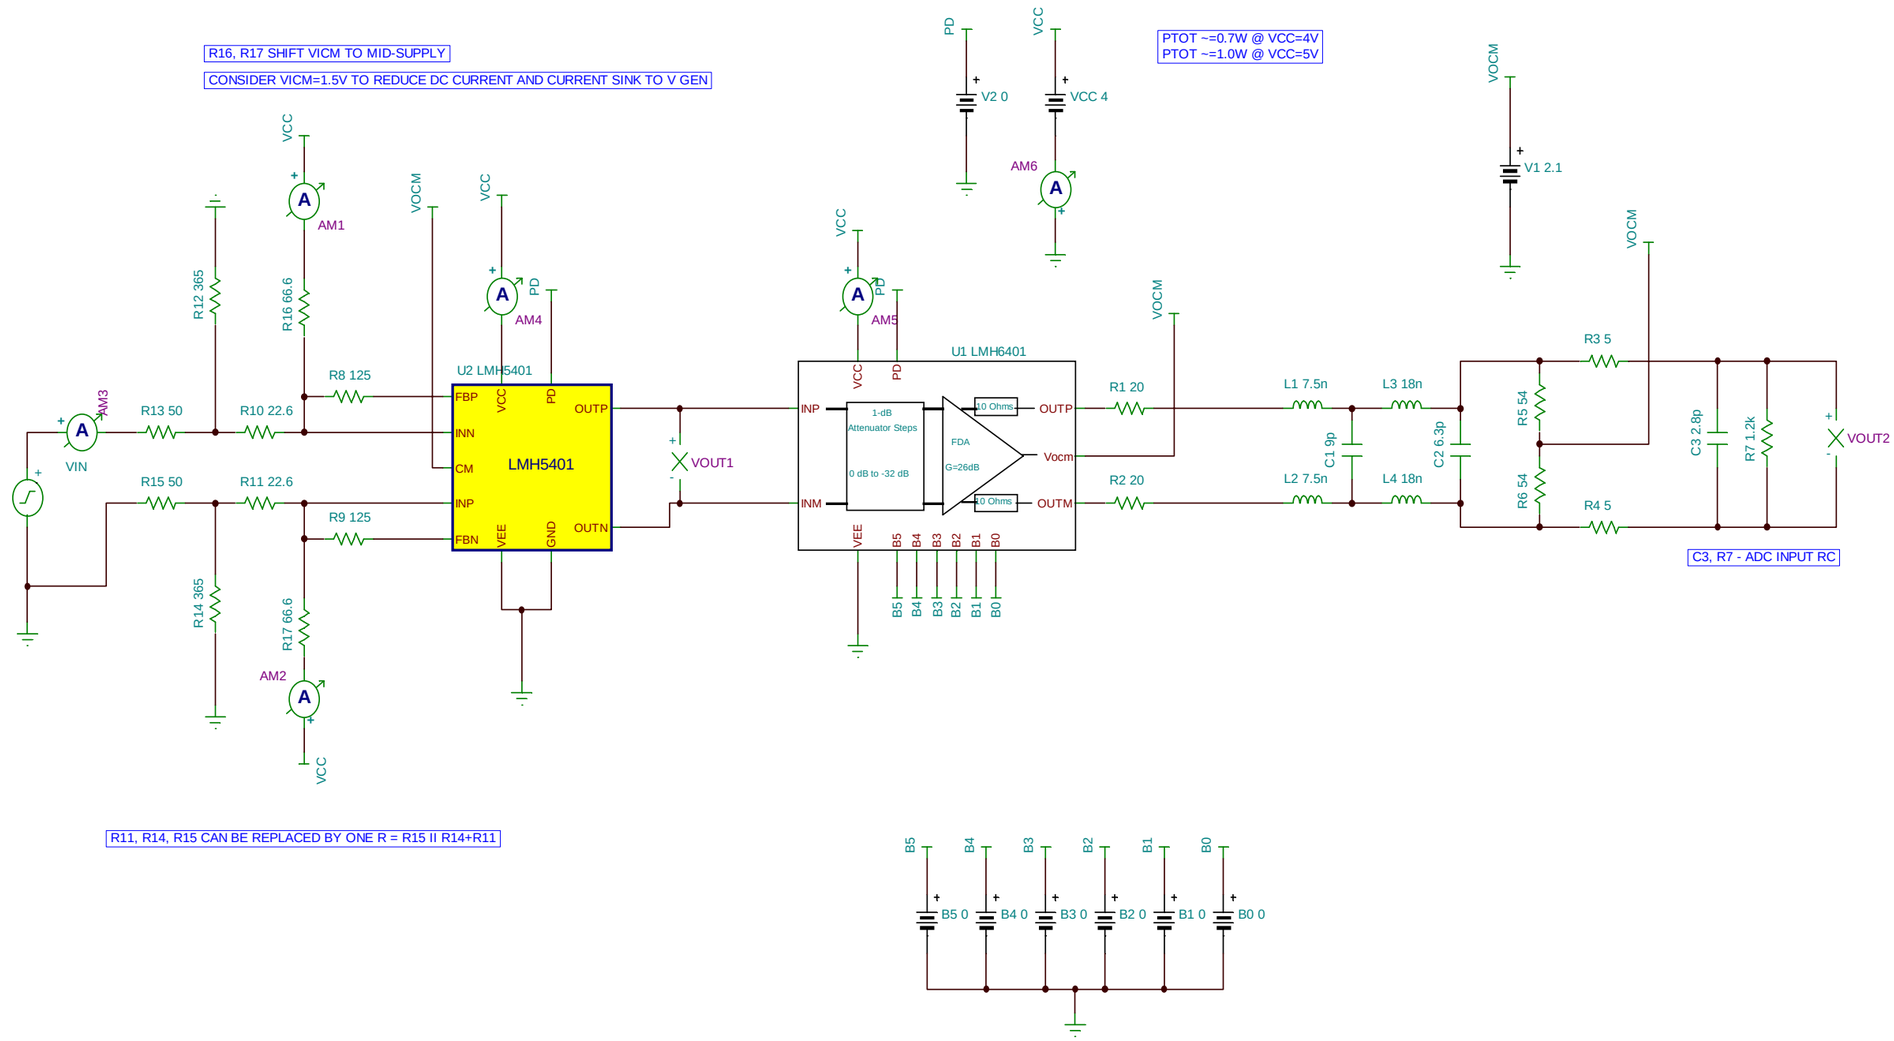
R16, R17 SHIFT VICM TO MID-SUPPLY
CONSIDER VICM=1.5V TO REDUCE DC CURRENT AND CURRENT SINK TO V GEN
PTOT ~=0.7W @ VCC=4V
PTOT ~=1.0W @ VCC=5V
C3, R7 - ADC INPUT RC
R11, R14, R15 CAN BE REPLACED BY ONE R = R15 II R14+R11
U2 LMH5401
LMH5401
FBP
INN
CM
INP
FBN
VCC
PD
VEE
GND
OUTP
OUTN
U1 LMH6401
INP
INM
1-dB
Attenuator Steps
0 dB to -32 dB
FDA
G=26dB
10 Ohms
Vocm
VIN
VOUT1
VOUT2
AM1
AM2
AM3
AM4
AM5
AM6
V2 0
VCC 4
V1 2.1
R12 365
R16 66.6
R8 125
R13 50
R10 22.6
R15 50
R11 22.6
R9 125
R14 365
R17 66.6
R1 20
R2 20
L1 7.5n
L2 7.5n
L3 18n
L4 18n
C1 9p
C2 6.3p
R5 54
R6 54
R3 5
R4 5
C3 2.8p
R7 1.2k
VOCM
B5
B4
B3
B2
B1
B0
B5 0
B4 0
B3 0
B2 0
B1 0
B0 0
